West Yamba Urban Release Area

Traffic Impact Assessment

ADDENDUM: IR RESPONSE COVER LETTER

This letter has been prepared in response to the Information Request (IR) issued by Clarence Valley Council (Council) dated 3rd March 2023 in relation to the proposed subdivision located within the West Yamba Urban Release Area (SUB2023/0001).

Figure 4.3: Yamba Road / Carrs Drive SIDRA Intersection Layout

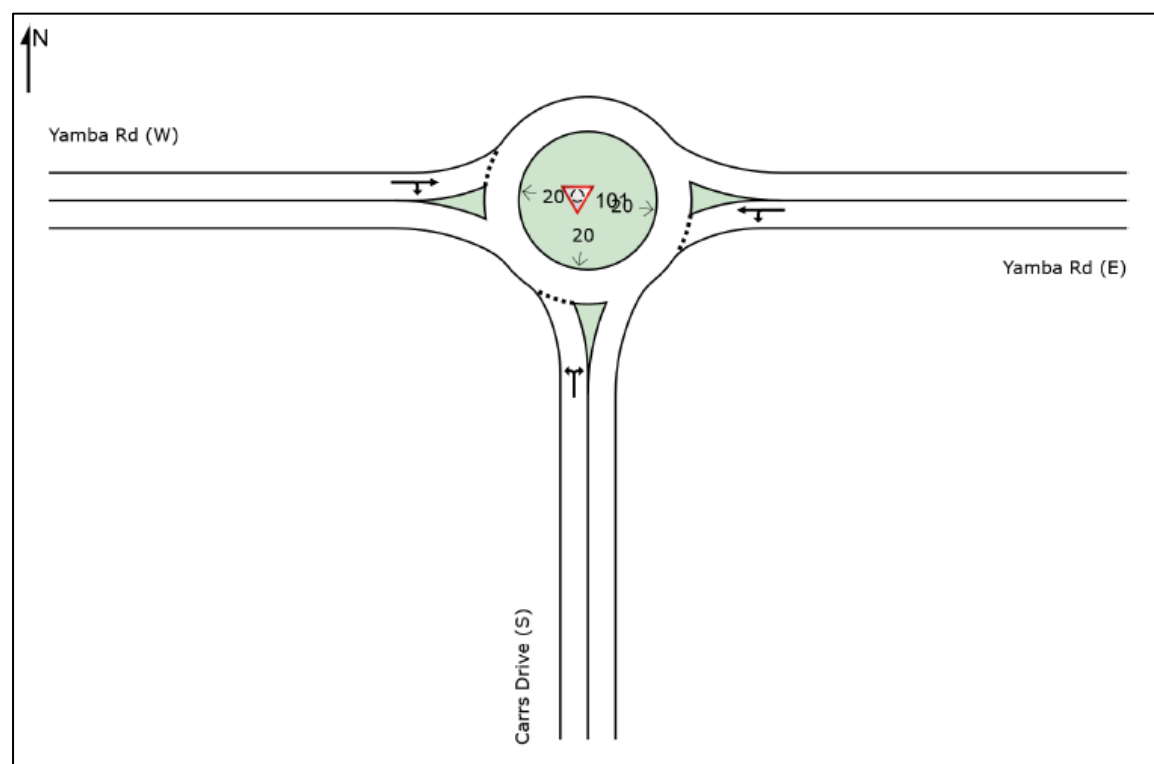
Ref.	IR Item	Response Summary	Section
Transport Assessment			
15	<i>The Traffic Impact Assessment (TIA) states that the Yamba Road/Carrs Drive intersection cannot cater for ultimate WYURA traffic volumes if it is the only vehicular access point to the WYURA. Section 4.8.1 states that the Golding Street connection to the WYURA is required based on two maximum thresholds. Further information is required to determine at which stage the Golding Street connection is required for this development.</i>	Development thresholds at which the Golding Street connection are required are identified in Section 4.8.1	Section 4.8.1
16	<i>The applicant is requested to provide information about if the proposed development stand alone without any connection to Golding Street. It is assumed that the emergency vehicle access to Golding Street via Miles Street will be required with the first stage of the development to ensure the development has two access point (albeit limited to emergency access only). How will general traffic be restricted or managed to ensure the section of road between the future Miles Street roundabout and Golding Street is not used as the primary point of access.</i>	Details of proposed emergency access are outlined in Section 1.3.2.	Section 1.3.2

Based on the above, and consistent with WYURA planning, the Golding Street connection is demonstrated to be required to facilitate efficient distribution of WYURA traffic onto the external road network. Further assessment to determine the trigger point for the Golding Street connection is provided at Section 4.8.1.

Figure 4.7: Yamba Urban Bypass Deering Street Connection

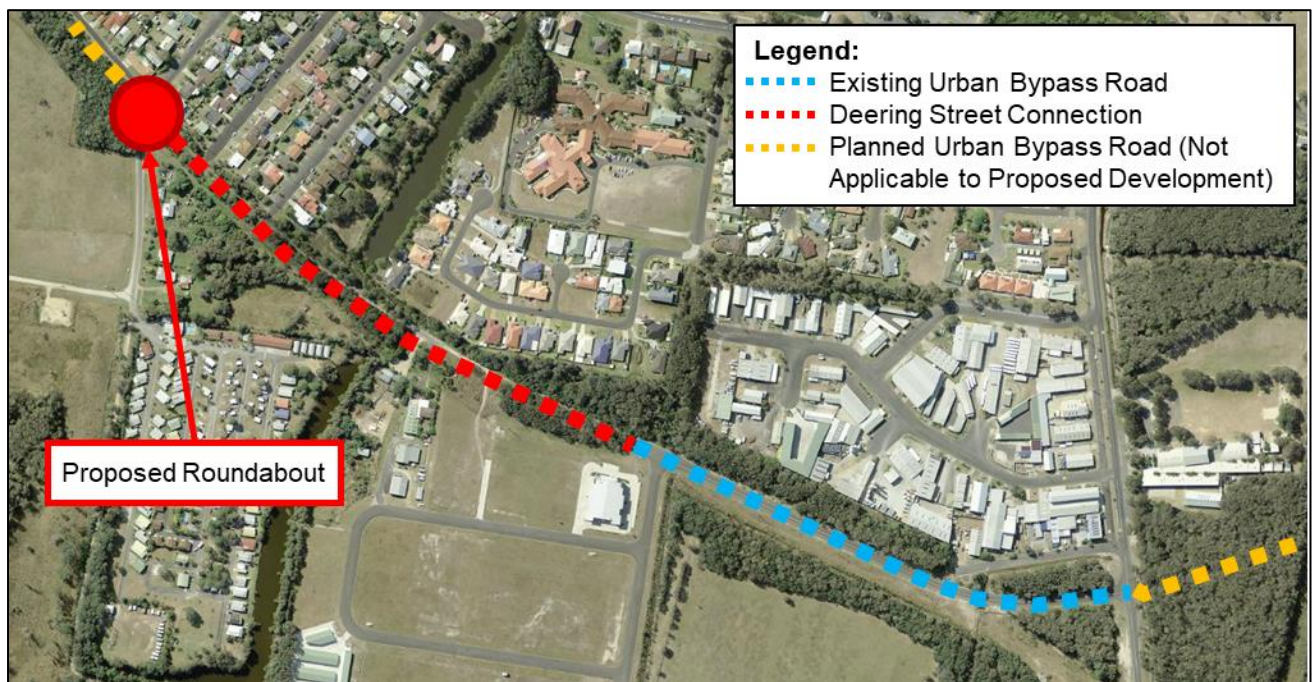
21	<i>Additional details shall be provided for the Golding Street/Yamba Road roundabout upgrade in the form of concept design plans. Plans shall indicate the extent of widening required within the road reserve and its impacts on neighbouring property boundaries (if any).</i>	<p>Detailed assessment of the geometric requirements of the Yamba Road / Golding Street roundabout upgrade identified that the upgrade would impact adjacent property boundaries.</p> <p>With consideration to this, further refinements were made to the traffic modelling. With these refinements it was determined that the Yamba Road / Golding Street intersection would only be expected to fail in the worst case 2043 AM, with seasonality factor, with development assessment scenario.</p> <p>By the time that this failure is forecast to occur (i.e. by 2043) it is expected that the Yamba Urban Bypass would be at least partially constructed. This bypass connection between Golding Street and Angourie Road would relieve pressure off Yamba Road and the Yamba Road / Golding Street. This connection is therefore anticipated to offset the impacts of development traffic on the Yamba Road / Golding Street intersection.</p> <p>As a part of the proposal, the development will provide the Golding Street / Deering Street roundabout and provide additional development contributions in accordance with Council's bypass S94 plan.</p> <p>The proposed development is therefore considered to contribute to the majority of the remaining bypass connection between Golding Street and Angourie Road.</p> <p>The proposed development is therefore considered to suitably offset development traffic impacts to the Yamba Road / Golding Street intersection without the provision of the upgrade initially identified.</p>	Section 4.8.2

This planned link would provide an alternate local connection between the WYURA and the Yamba Town Centre to the east thereby significantly reducing WYURA traffic flows via Yamba Road and importantly at the Yamba Road / Golding Street roundabout.

Noting that traffic flows at the Yamba Road / Golding Street roundabout are only expected to marginally exceed the capacity of the roundabout, the Deering Street connection between Golding Street and Angourie Road alone is expected to offset impacts on Yamba Road. As illustrated in Figure 4.7 the eastern portion of this Deering Street connection is already constructed. Also, as shown at **Appendix A**, a roundabout is proposed as a part of the development at the Golding Street / Deering Street intersection at the western end of this connection.

Based on the above, the proposed development will contribute to the Deering Street connection portion of the Yamba Urban Bypass through the provision of the roundabout as well as contributions in accordance with the Bypass S94 plan (in addition to standard development contributions). As such, the development will be contributing to the majority of the expected cost of the remaining bypass between Golding Street and Angourie Road.

With the proposed development and other developments within the WYURA it is expected that this connection will be warranted / provided by 2043. By providing a majority contribution to this connection, which offsets impacts on Yamba Road / Golding Street intersection previously identified, the proposed development is considered to provide appropriate mitigation measures to offset the impact of development traffic on the external road network.

Figure 5.2: Carrs Drive / Proposed Collector Road Turn Warrants Assessment

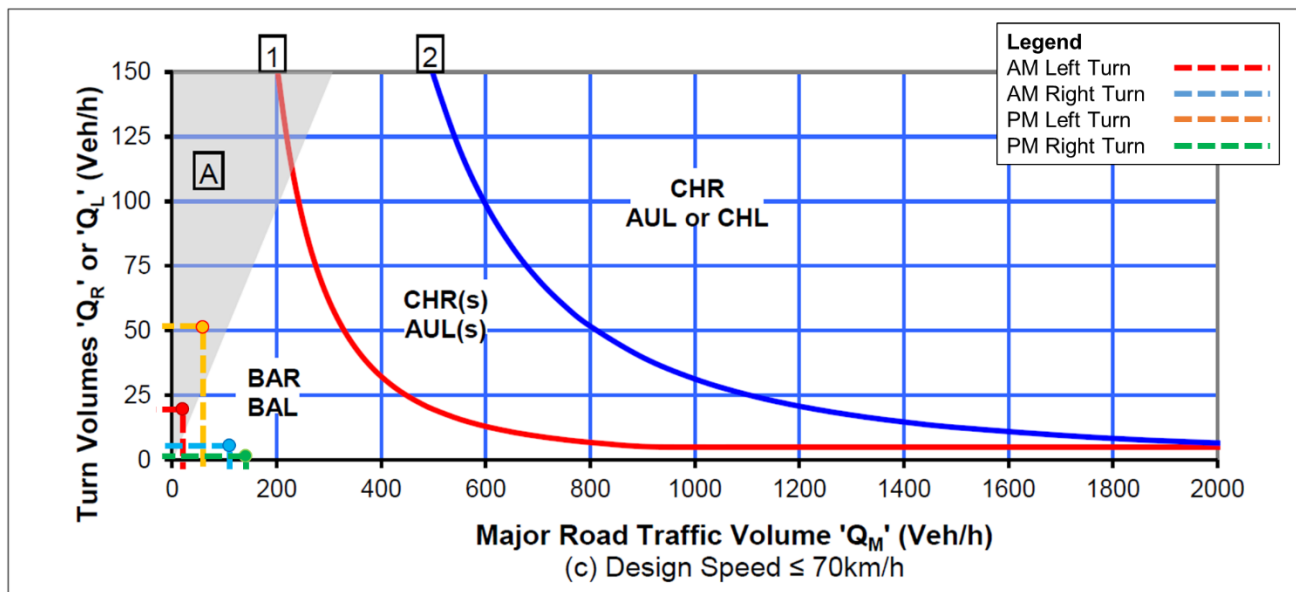
17	<i>The traffic report indicates that the new road and intersection onto Carrs Drive will function as a Collector Road. It is unclear if an assessment of this proposed intersection has been undertaken to determine its required level of treatment. The TIA shall be revised to include an assessment of the proposed new intersection into Carrs Drive to determine the appropriate intersection treatment required. Appropriate Concept Plans of the intersection treatment are to be provided.</i>	This traffic assessment has been revised to include assessment of the future Carrs Drive / Collector Road intersection. It has been determined that a BAR treatment is required on Carrs Drive with the intersection form as per the Carrs Drive / Miles Street intersection.	Section 5.3 Appendix E
18	<i>Section 5.3 of the Traffic Impact Assessment recognises the requirement for a BAR treatment at the Carrs Drive/Miles Street intersection. Revised plans shall be submitted which include preliminary intersection configurations for accesses to Carrs Drive/Miles Street.</i>	Concept plans of the proposed Carrs Drive / Miles Street intersection including a BAR treatment have been provided by MUS as a part of the Development Application	N/A

As shown, basic left-turn (BAL) and basic right-turn (BAR) treatments are sufficient to cater for the ultimate traffic volumes at the Carrs Drive / Miles Street and Carrs Drive / Proposed Collector Road intersections.
